18 August 2025
BMC26010: 702 Boundary Road, Coopers Plains

**RE: 702 Boundary Road, Coopers Plains
Traffic Engineering Response to Information Request
Brisbane City Council Application Reference: A006780825**

REVISED FRONT CUSTOMER PARKING LAYOUT

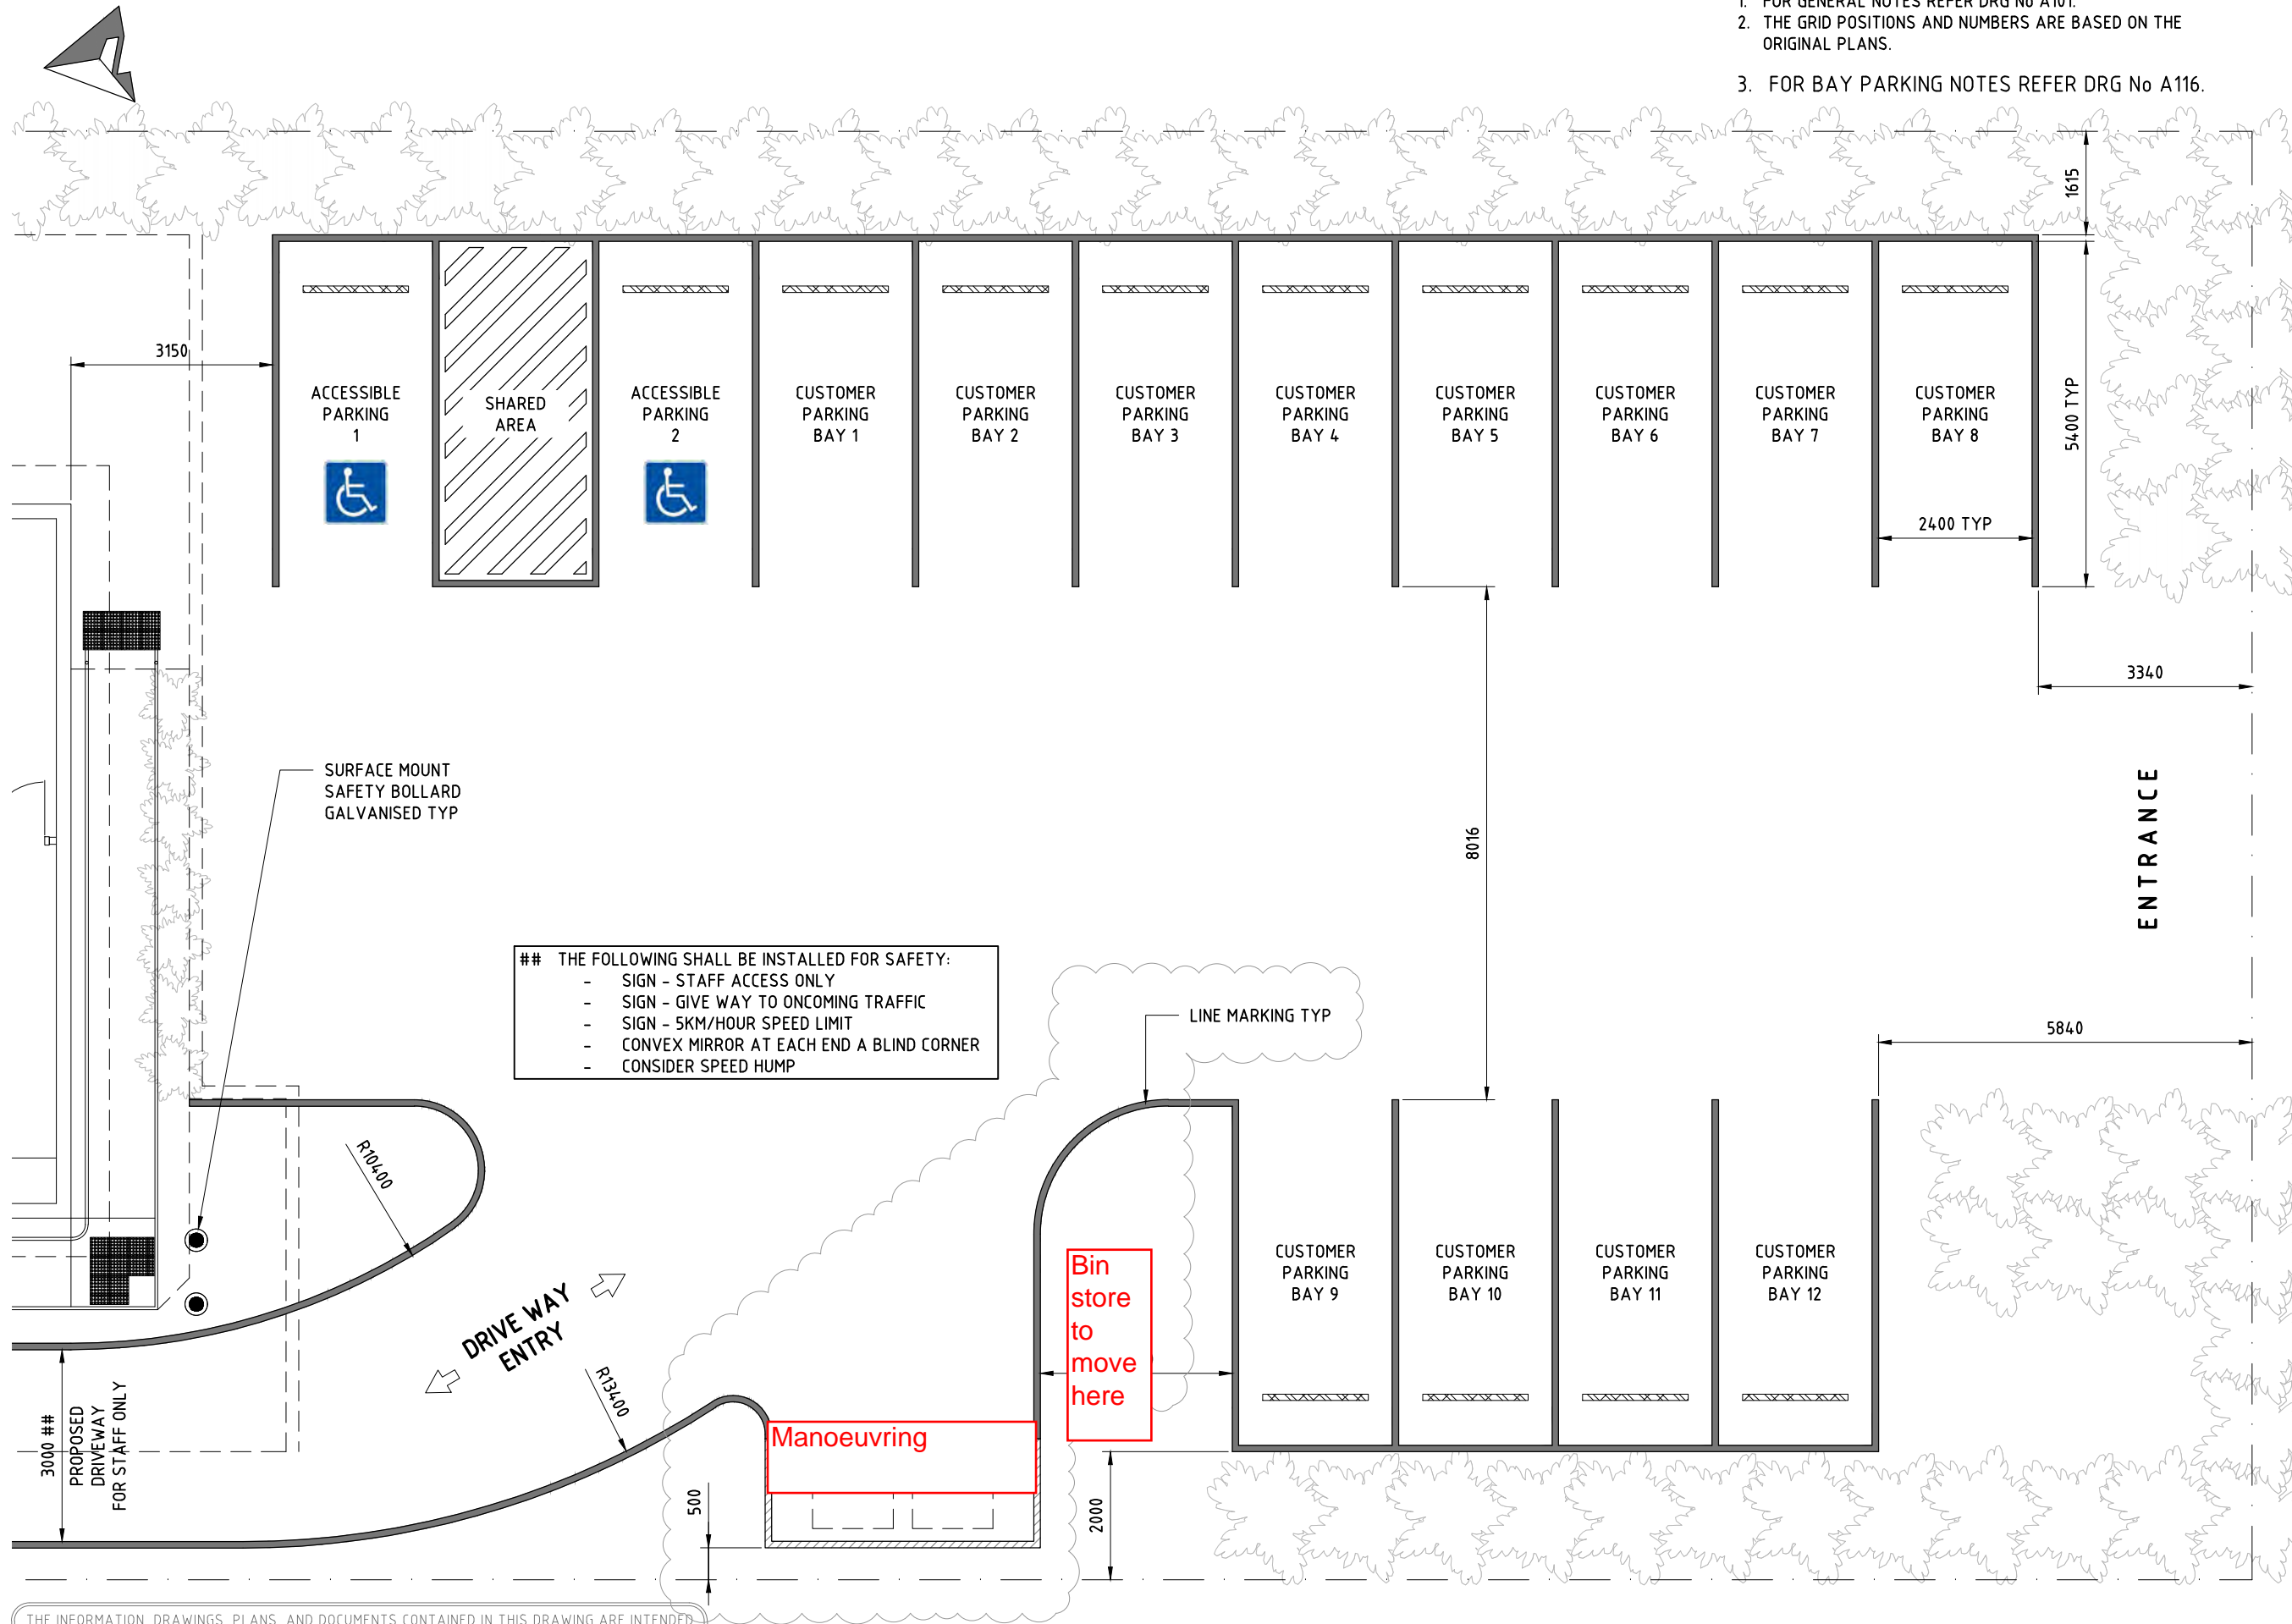
It is noted that the existing approval demonstrates a "Refuse Collection Bay" and "Refuse Turning Bay" to facilitate on-site servicing by a Refuse Collection Vehicle (RCV). The proposal amends the previously approved car parking layout and removes the refuse collection bay and refuse turning bay. It is not clear how servicing will be achieved given the development is on an arterial road and therefore, must achieve a forward in/forward out manoeuvre.

- a. In accordance with PO16/AO16.2 of the industry code and PO19/AO19.2, AO19.3 of the Transport, access, parking and servicing code, provide a RPEQ certified swept path analysis demonstrating a RCV as specified in BSD 3008-2, can safely and efficiently service the development. Or;*
- b. If proposing to utilise a design vehicle other than that stated in Table 3 of the Refuse planning scheme policy, provide written confirmation from a private waste collection contractor that they have a design vehicle in their fleet that can service this specific site, noting the site constraints and the forward in, forward out manoeuvre. Ensure a RPEQ certified swept path analysis is provided demonstrating that the proposed design vehicle can safely and efficiently provide on-site servicing.*

To address the Information Request, changes have been made to the proposed site layout plan, with the changes shown at Attachment A to this advice. Specifically, this includes the addition of a turning area for the Refuse Collection Vehicle (**refer not above in relation to further changes**).
